DO - No. EASA.21J.020	Service Letter SL 66	Revision 1
--------------------------	---------------------------------	------------

Replacement of Outer Blade Bearings

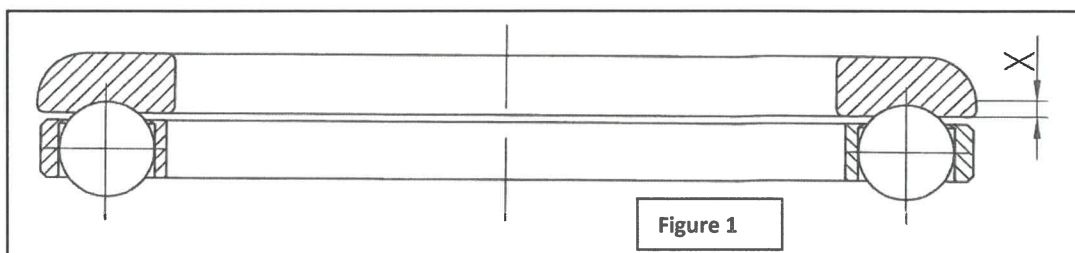
The radius of the outer blade bearing is slightly offset to the center position and can cause in the propeller hub small scratches (see Figure 1).

If dimension X is bigger than 1,8 mm (0,0708 inches), replace bearing and inspect hub for a possible scratch in the blade bearing hub seat.

If a scratch in the hub is found, please contact MT-Propeller Techsupport!

X = Maximum Dimension for the Start of the Radius 1,8 mm (0,0708 inches).
If bigger, replace bearing and inspect hub for scratches!
